El Paso County Park Advisory Board

Agenda Item Summary Form

Agenda Item Title: Homestead North at Sterling Ranch Phase I Preliminary Plan

Agenda Date: January 13, 2021

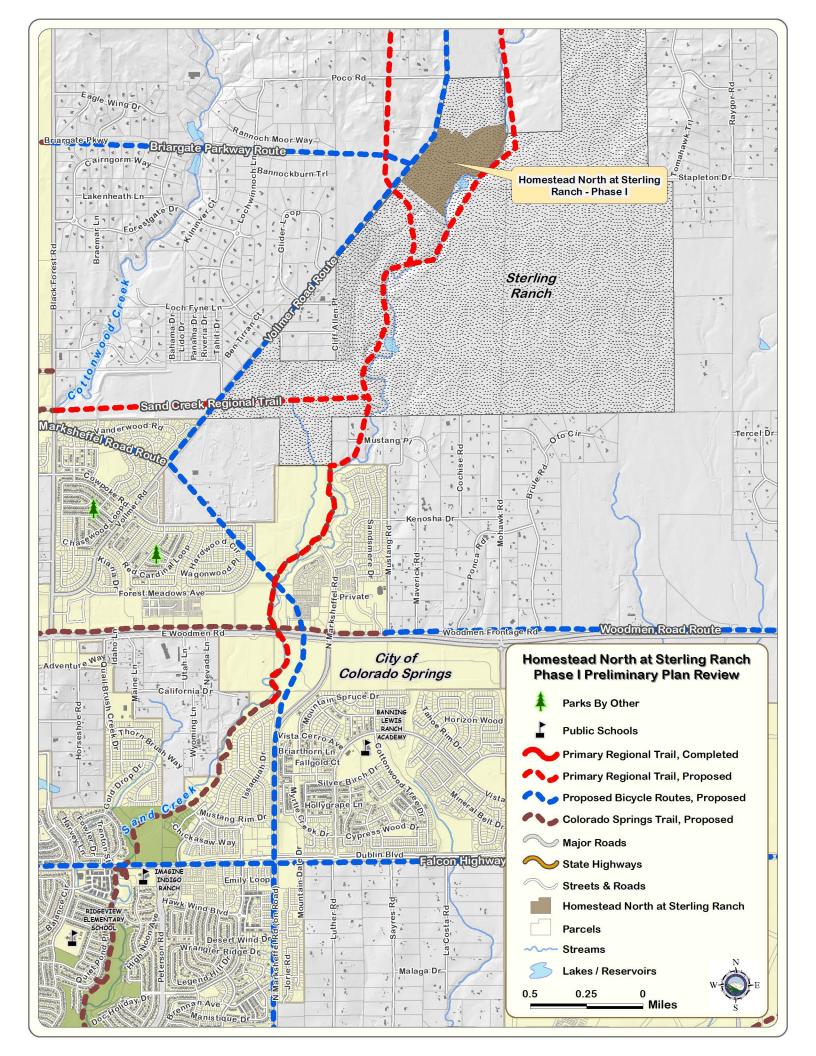
The 2013 El Paso County Parks Master Plan shows a proposed regional trail connection impacted by the project. The proposed Sand Creek Primary Regional Trail alignment traverses generally north-south through the eastern portion of the property, along the western bank of Sand Creek. Furthermore, the proposed Vollmer Road Bicycle Route is located immediately west of the project location. A dedicated public right-of-way already exists along the aforementioned bicycle route, so no easement requests are necessary at that location; however, the applicant is advised that multi-model transportation options will be developed within the rights-of-way in the future. The property is not located within any candidate open space land, as the Black Forest South Candidate Open Space is located approximately 0.75 miles to the northwest.

The proposed Sand Creek Regional Trail is depicted in the Preliminary Plan, and labeled as "10' County Gravel Trail," although when constructed, the trail will follow EPC Parks Tier I Trail standards with an 8' wide crusher fine trail surface with 2' natural shoulders. The Preliminary Plan also shows concrete sidewalks/trails located adjacent Vollmer Road and the future Briargate Parkway extension. These non-County trails will allow for direct off-street connectivity to the Sand Creek Regional Trail for the residents and visitors of Sterling Ranch.

Due to the location of the Sand Creek Primary Regional Trail within the Homestead North at Sterling Ranch Phase I development, El Paso County Parks staff recommends that the applicant designate, provide, and dedicate to El Paso County a 25-foot trail easement that allows for the construction and maintenance of the regional trail. Furthermore, staff recommends fees in lieu of land dedication for regional and urban park purposes.

The Park Advisory Board recommends that the Planning Commission and the Board of County Commissioners include the following conditions when considering and/or approving the Homestead North at Sterling Ranch Phase I Preliminary Plan: (1) designate and provide to El Paso County a 25-foot trail easement through Homestead North at Sterling Ranch, within Tract F, that allows for construction and maintenance of the Sand Creek Primary Regional Trail, and dedicate the easement to El Paso County prior to the recording of the forthcoming final plat(s); 2) include descriptions, drawings, and locations of the two neighborhood parks in the Letter of Intent and Preliminary Plans, respectively; 3) fees in lieu of land dedication for regional park purposes in the amount of \$68,649 and urban park fees in the amount of \$43,365 will be required upon recording of the forthcoming final plat(s). A Park Lands Agreement may be an acceptable alternative to urban park fees, provided the agreement is approved by the County and executed prior to recording the forthcoming final plat(s).
